RESOLUTION NO. 22-49

A RESOLUTION OF THE TOWN COMMISSION OF THE TOWN OF DUNDEE, FLORIDA, APPROVING THE CERTIFIED SUBDIVISION PLAN (CSP) WITH CERTAIN CONDITIONS FOR THE LANDINGS AT LAKE MABEL LOOP SUBDIVISION; MAKING FINDINGS; AND AUTHORIZING THE TOWN MANAGER TO TAKE ALL NECESSARY FURTHER ACTION(S) RELATED TO ENTERING INTO A DEVELOPER'S AGREEMENT ON BEHALF OF THE TOWN OF DUNDEE WITH REGARD TO THE CONDITIONAL APPROVAL OF THE CSP FOR THE LANDINGS AT LAKE MABEL LOOP; PROVIDING FOR SEVERABILITY; PROVIDING FOR THE ADMINISTRATIVE CORRECTION OF SCRIVENER'S ERRORS; AND PROVIDING FOR AN EFFECTIVE DATE.

RESOLUTION 22-49 EXHIBIT B
CERTIFIED SUBDIVISION PLAN

RE: Landings at Lake Mabel Loop Resubmittal Certified Subdivision Plan review comments
RES #: 22-101

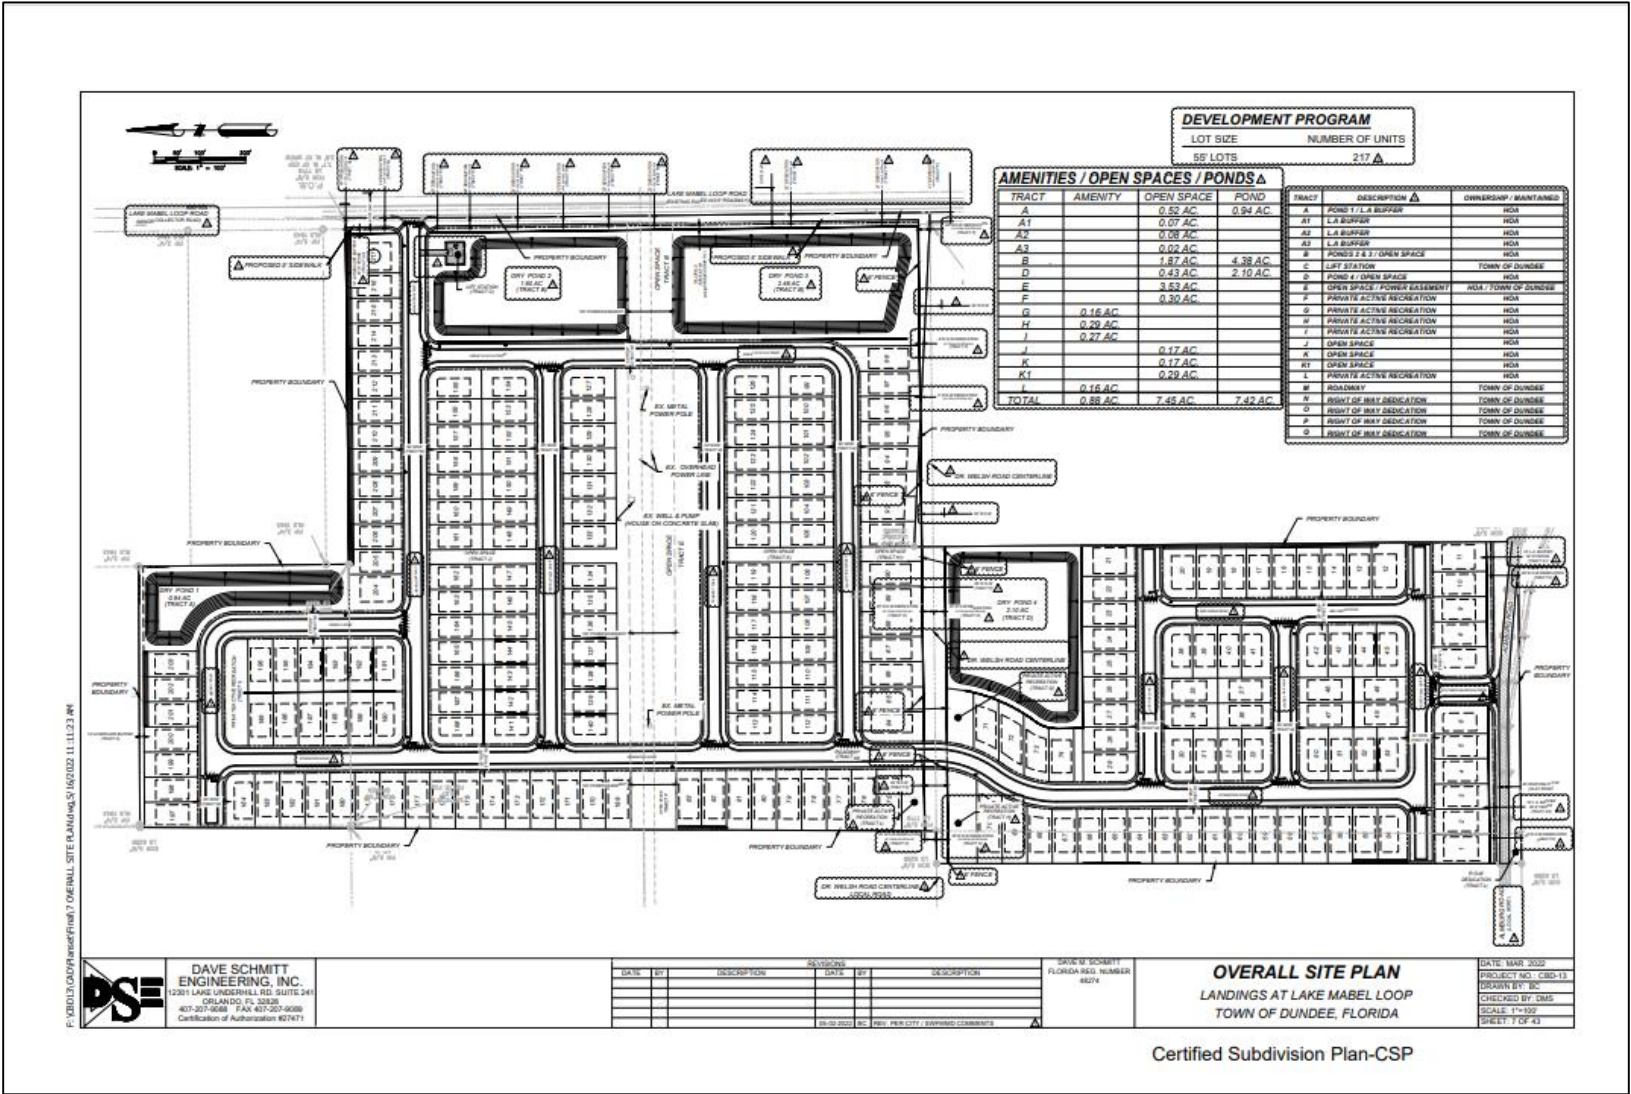
1. In many places, inadequate easement space has been provided for the stormwater pipe in the easement to be maintained. Easements must be a minimum width calculated as follows: pipe diameter + 2 feet on each side + (2 x depth to invert). Please review all easements and revise plans accordingly. Minimum easement width is 20 feet. Two examples can be seen between lots 82 and 83, and between lot 74 and 28/29, but all easements should be reviewed and corrected as needed.

2. All stormwater pipes located within individual lots shall be located within drainage easements. Please add these easements to the plans, taking into account the minimum 20-foot easement width and other width requirements based on pipe depth, as discussed above.

3. Many of the stormwater and sanitary sewer pipes seem unnecessarily deep. Town preference is that pipes and manholes should be maximum 12 feet deep unless unavoidable. Please review all pipe depths and minimize depths to the extent possible. Use drop manholes and add additional manholes with grade breaks where necessary.

4. Multiple intersection curb returns do not show grades that will result in positive drainage around the curb return and will result in ponding at some location on the curb return, e.g., at the handicap access ramp in several instances. An example of this is at the southeast curb return of the intersection of Rosewood Road with Slash Pine Street, shown on Sheet 9 of 43. Please review all intersections and curb return grades and revise as necessary to ensure positive drainage at all points.

5. In several locations leading into the storm ponds, larger pipe sizes of 30", 36", 42" and 48" diameter are called out. Please review the size of the structures to which these pipes connect to be sure the structure type called for can fit those pipe sizes. It appears that some of the structures called for are too small for the pipes they must serve.

6. Similarly, please review minimum manhole diameters for deep manholes. No notes are shown specifying manhole diameter requirements for deeper manholes. Minimum manhole inside diameter shall be 48 inches for up to 12 feet deep, 60 inches for up to 18 feet deep, 72 inches for greater depths. (Haines City Specs 9.4.4.3)

17. Retaining walls are allowed up to a maximum height of 5 feet. The plans show retaining walls up to 9 feet high. Please review the plans and adjust as needed.

18. Provisions for collecting and conveying runoff at retaining walls from the upper lot to the lower lot must be shown on the CSP plans. The walls themselves fall under separate building permits, but related drainage and erosion-protection facilities must appear on the CSP.

27. In the water system calculations, the fire flow is stated to be 1500 gpm, but is shown as the sum of flow from two 750 gpm hydrants. Dundee Fire requires a minimum hydrant flow of 1000 gpm from each hydrant for 30 minutes at minimum residual pressure of 20 psi. Please review and revise the calculations accordingly.

29. Hydrants shall be spaced a maximum of 500 feet apart, measured as fire hose would be laid. It appears that not all the hydrants on the plans meet this criteria. One example is the distance between hydrant 9 to hydrant 18. Please review all hydrant locations and revise the plans as needed so hydrants are no farther apart than 500 feet.
